STATUS CODE DESCRIPTION  
**ISSUED FOR FURTHER INFORMATION**

PROJECT  
**ADAMSTOWN STATION BLOCKS ACD**

DRAWING  
**BLOCK A ELEVATIONS**

STATUS CODE: A1      DRAWING NUMBER: ADC3-HJL-ACD-ZZ-DR-A-P2010      REVISION: P02

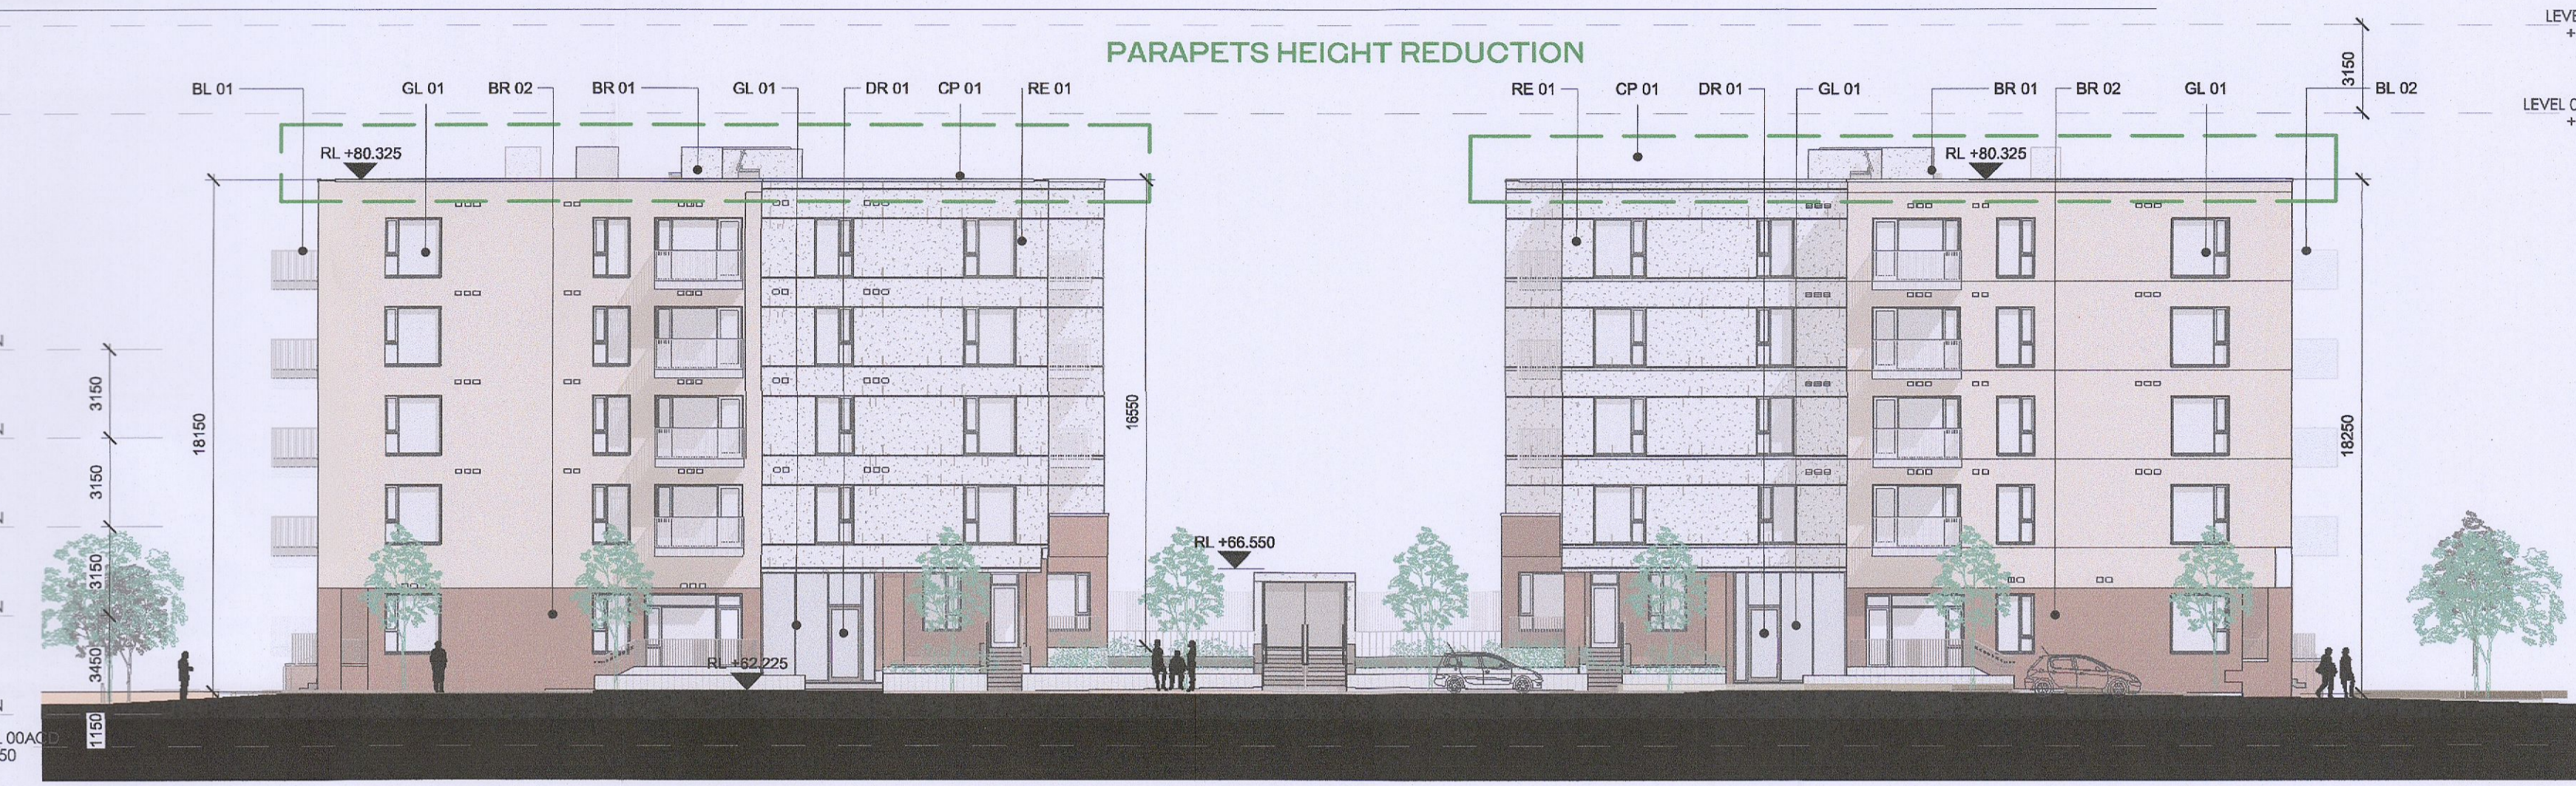
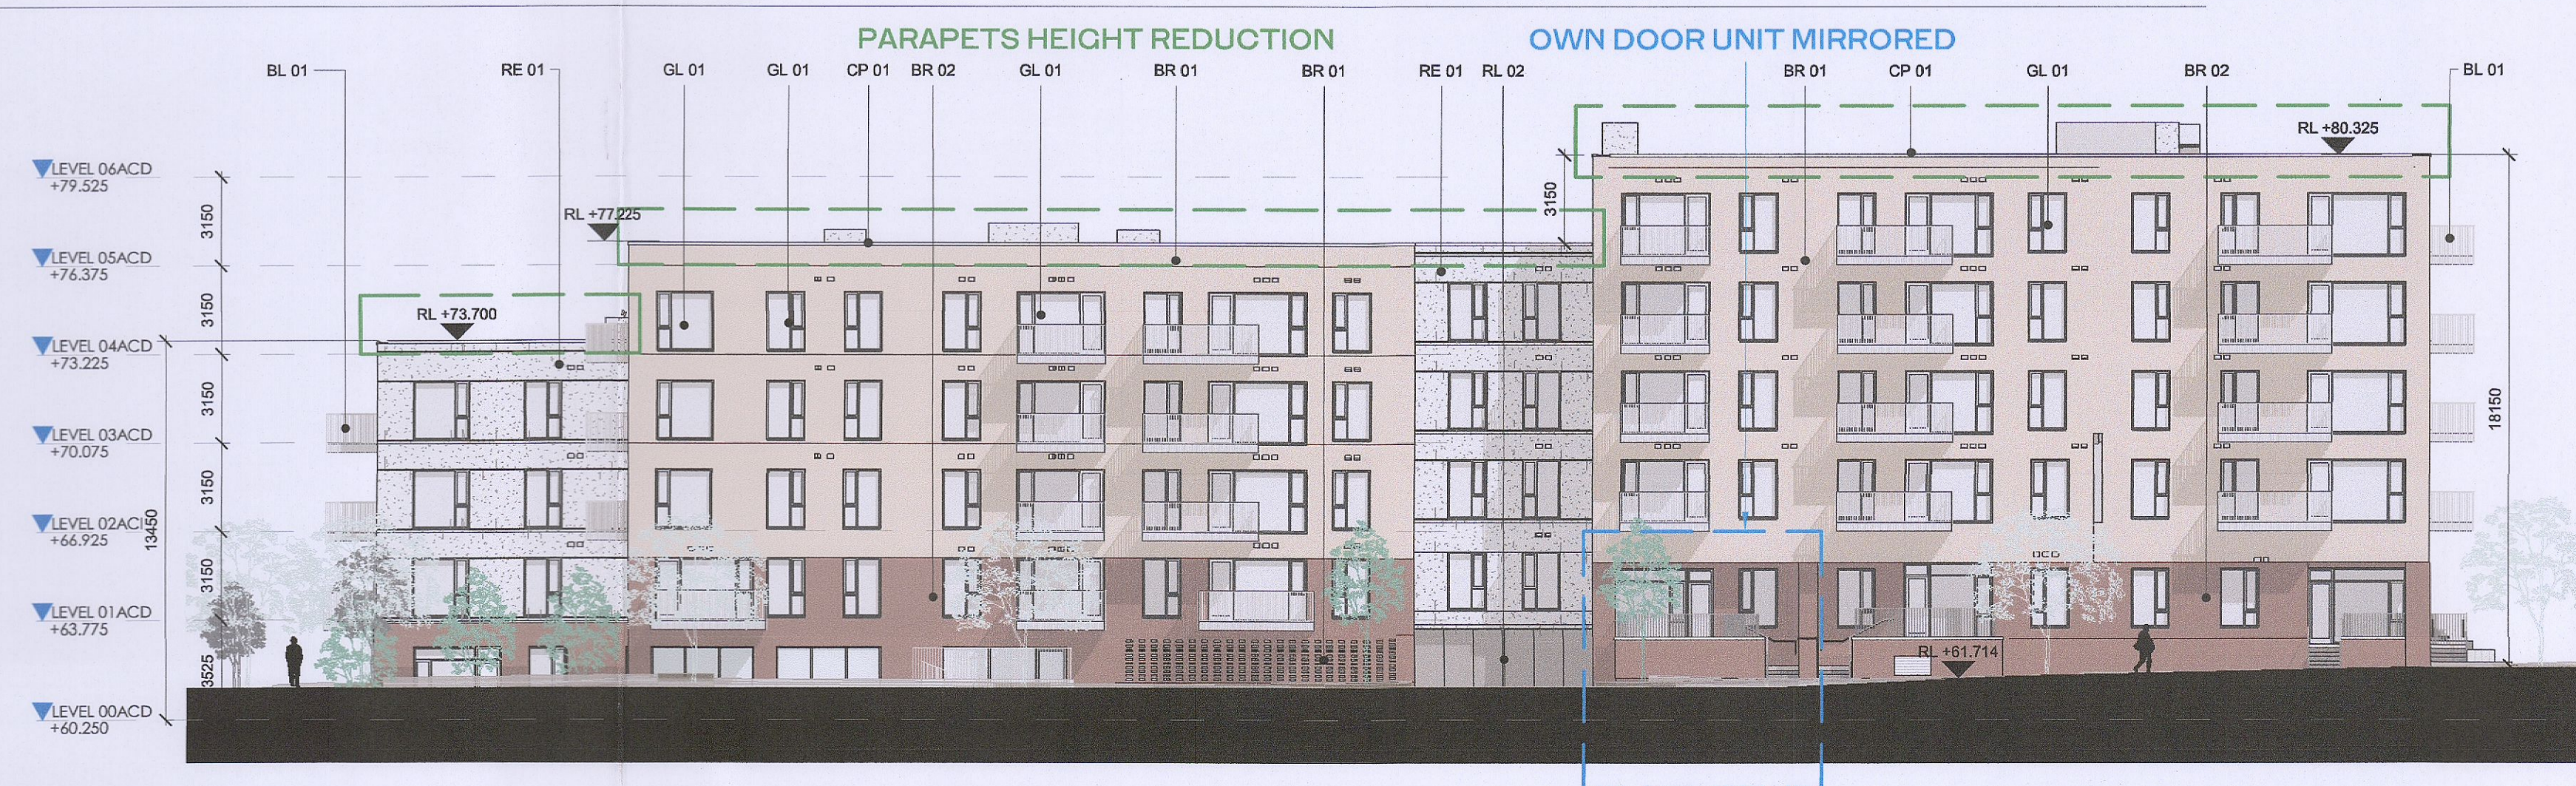
03 REDUCED PARAPET HEIGHT & FALL ARREST SYSTEM INTRODUCED TO BLOCKS A,C,D AND RESIDENT PAVILLION BUILDINGS DUE TO MAINTENANCE. PARAPET HEIGHT OF TOWER ELEMENT OF BLOCK C1 RETAINED AS PER ORIGINAL PLANNING APPLICATION
